ENDL TEXAS

Date: 7 May 2003
 To: T10 Technical Committee
 From: Ralph O. Weber
 Subject: Remove ULP and LLP from SAM-3

Figure 25 — Protocol service reference model

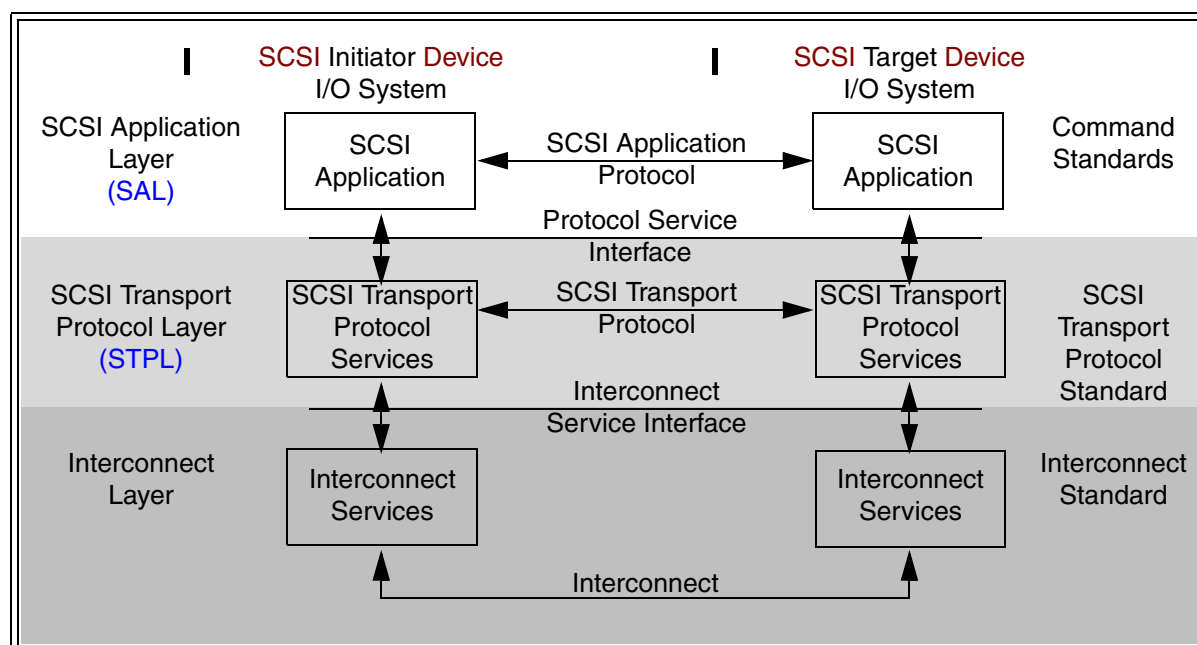
Change 5 [4.15 The SCSI model for distributed communications]: Revise the entire subclause as follows:

The SCSI model for communications between distributed objects is based on the technique of layering as shown in figure 25.

The layers comprising this model and the specifications defining the functionality of each layer are denoted by horizontal sequences. A layer consists of peer entities that communicate with one another by means of a protocol. Except for the interconnect layer, such communication is accomplished by invoking services provided by the adjacent ~~lower~~ layer. ~~By convention, the layer from which a request for service originates is called the upper level protocol layer or ULP layer. The layer providing the service is referred to as the lower level protocol layer or LLP layer.~~ The following layers are defined.

SCSI application layer (SAL): Contains the clients and servers that originate and process SCSI I/O operations by means of a SCSI application protocol;

SCSI transport protocol layer (STPL): Consists of the services and protocols through which clients and servers communicate; and

Interconnect layer: Comprised of the services, signaling mechanism and interconnect subsystem needed for the physical transfer of data from sender to receiver. In the SCSI model, the interconnect layer is known as the service delivery subsystem.

Figure 26 — **SCSI transport** protocol service model

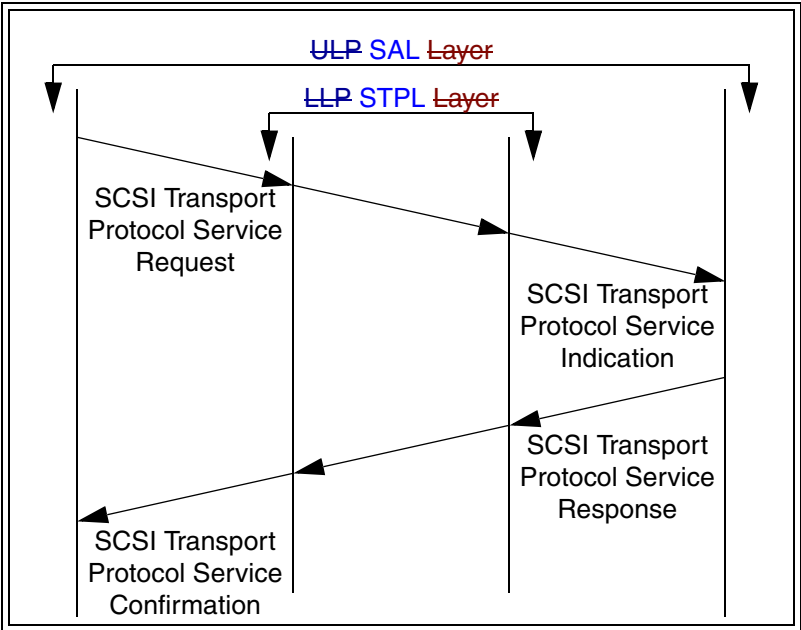
Figure 26 shows the relationships between the four **SCSI transport** protocol service types.

Figure 27 — Request-Response **ULP SAL** transaction and related **LLP STPL** services

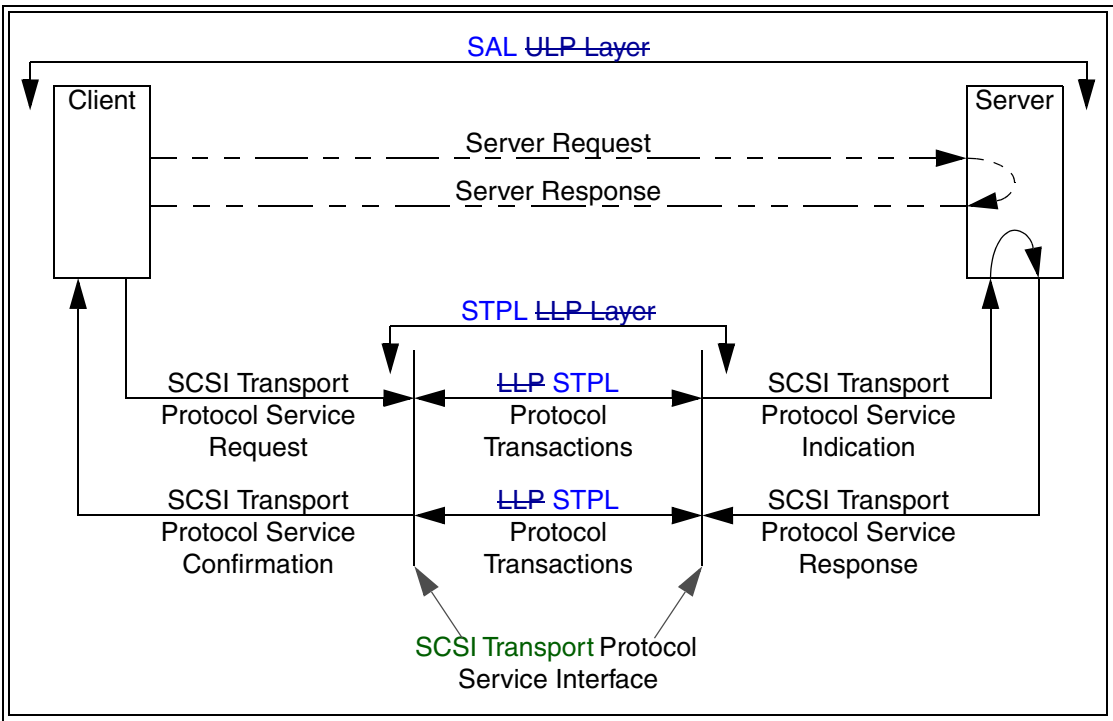
Figure 27 shows how **SCSI transport** protocol services may be used to process a client-server request-response transaction at the SCSI application layer.

The dashed lines in figure 27 show a SCSI application protocol transaction as it may appear to sending and receiving entities within the client and server. The solid lines in figure 27 show the corresponding SCSI transport protocol services and **LLP STPL** transactions that are used to transport the data.

Figure 28 — SCSI transport protocol service model for data transfers

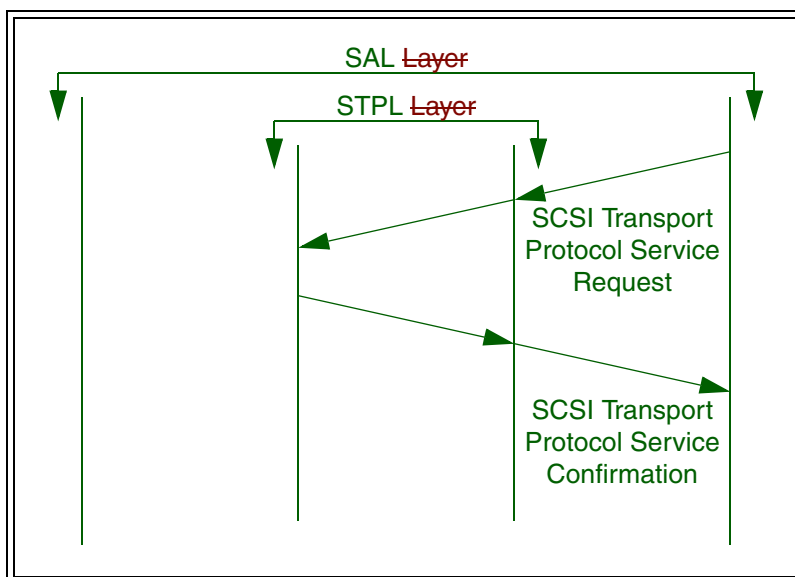
When a device server invokes a data transfer SCSI transport protocol service, the interactions required to transfer the data do not involve the application client. Only the STPL layer in the SCSI device that also contains the application client is involved. Figure 28 shows the relationships between the SCSI transport protocol service types involved in a data transfer request.

Figure 29 — Device server data transfer transaction and related STPL services

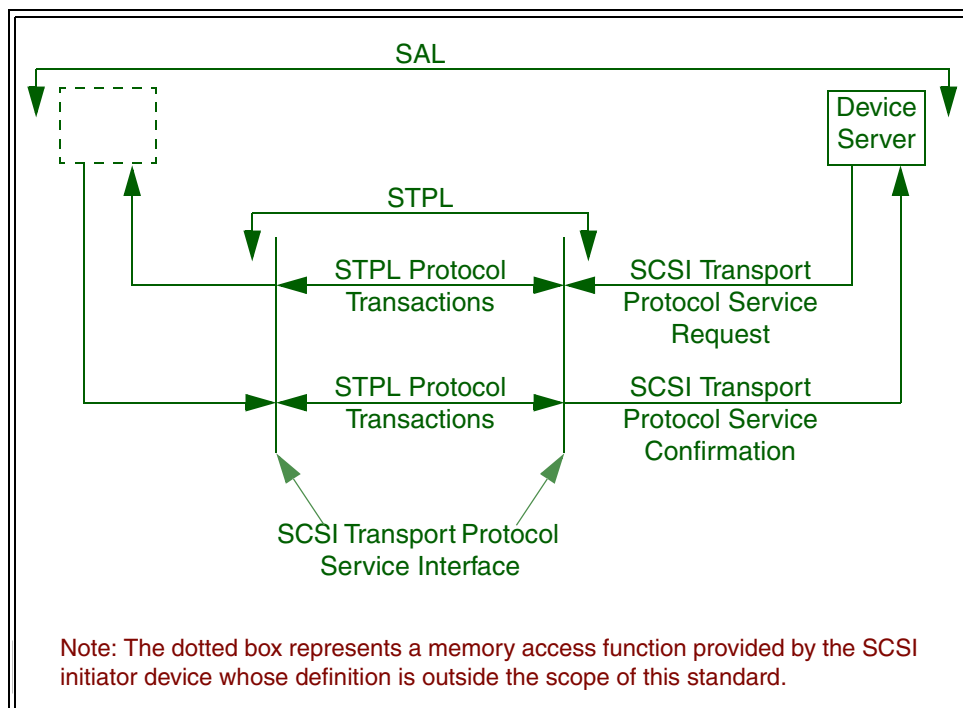
Figure 29 shows how SCSI transport protocol services may be used to process a device server data transfer transaction.
